Environmental Review Question – 9/27/06

Figure 11: Gross TLD readings at the fence line.

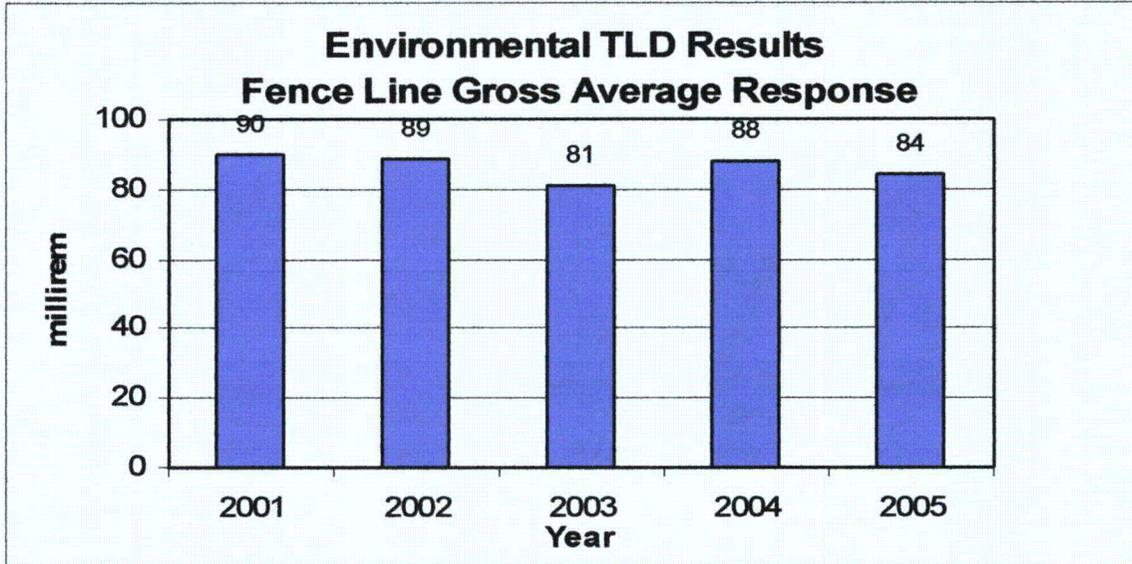
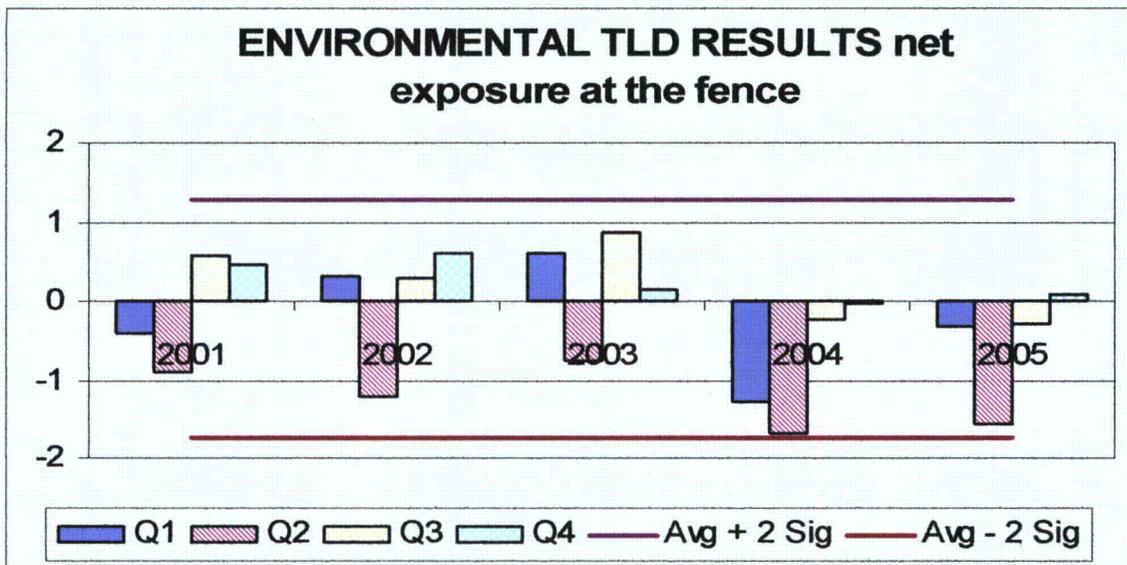
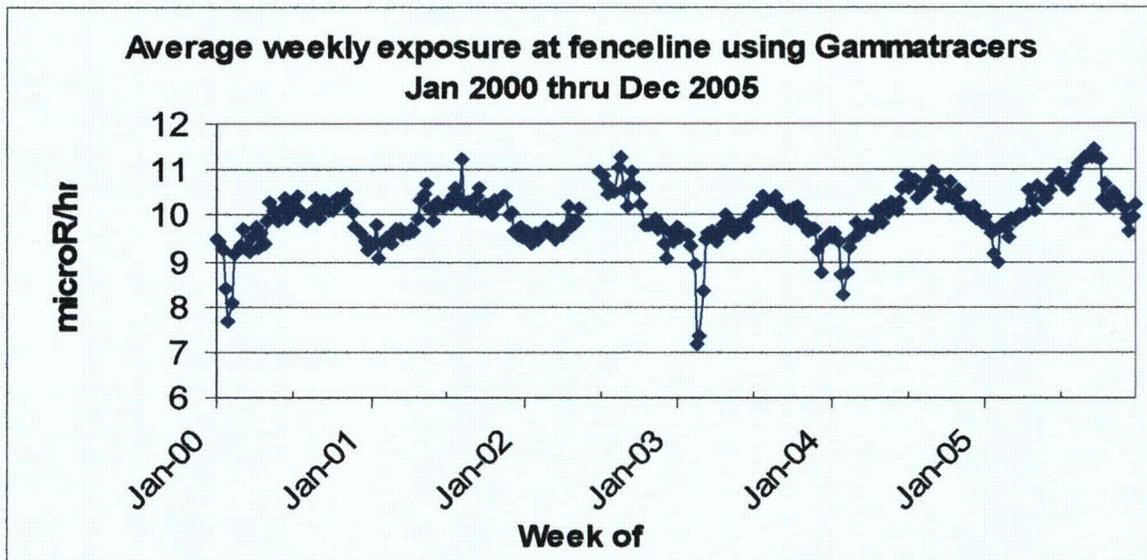
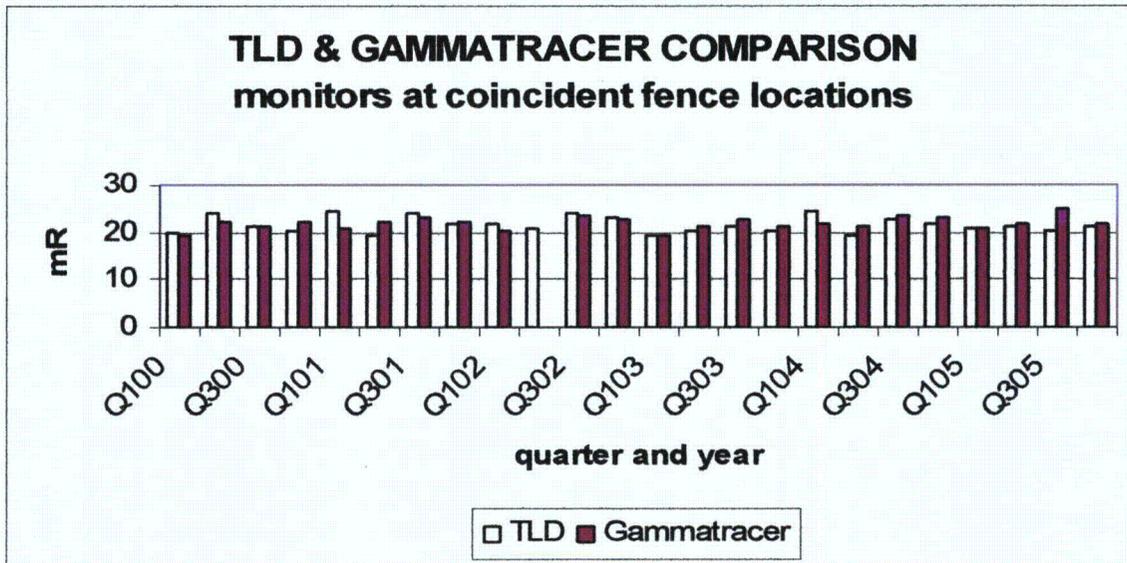
- 1. Provide a general program description of the environmental monitoring program.**
- 2. Provide results of the environmental monitoring (summary or previously prepared report preferred, raw data as a last resort).**

Monitoring for gamma radiation is performed at the fence line using TLDs and a real-time environmental monitoring system, trade named GammaTracer. Figure 11 presents the gross annual TLD readings at the fence line for the last five years. Monitoring using TLDs is performed quarterly at 16 locations on the fence line and at 7 locations offsite. The offsite locations are used to determine the natural ambient background levels for this region. Figure 12 shows the net value (difference) between the average of the measured values at fence line locations and the average of the measured values from offsite background locations, for a given monitoring period. For statistical reasons a net value may be less than, equal to, or

Monitoring using GammaTracers is performed at 16 locations on the NIST boundary fence line which coincide with the TLD locations. Figure 13 shows the weekly mean dose rate at the fence line averaging data from all the GammaTracers. The low readings in February 2003 were a result of large amounts of snow on the ground for an extended period, which shielded the detectors from naturally occurring radioactive materials in the soil, and inhibited the release of radon into the air. The blank period in 2002 occurred while the units were returned to the manufacturer for battery replacements.

Figure 14 shows a comparison between the gross TLD results in mR and the integrated GammaTracer results in mR for those locations where they are co-located. The data shows no statistically significant systematic difference between the active response Gamma Tracer results and the passive response integrated dose TLD results.

In summary, the environmental monitoring program indicates no measurable direct exposure beyond normal environmental background at the NIST boundary. The environmental sampling of grass, soil, and water also showed no indication of anything other than those normally found in the environment.
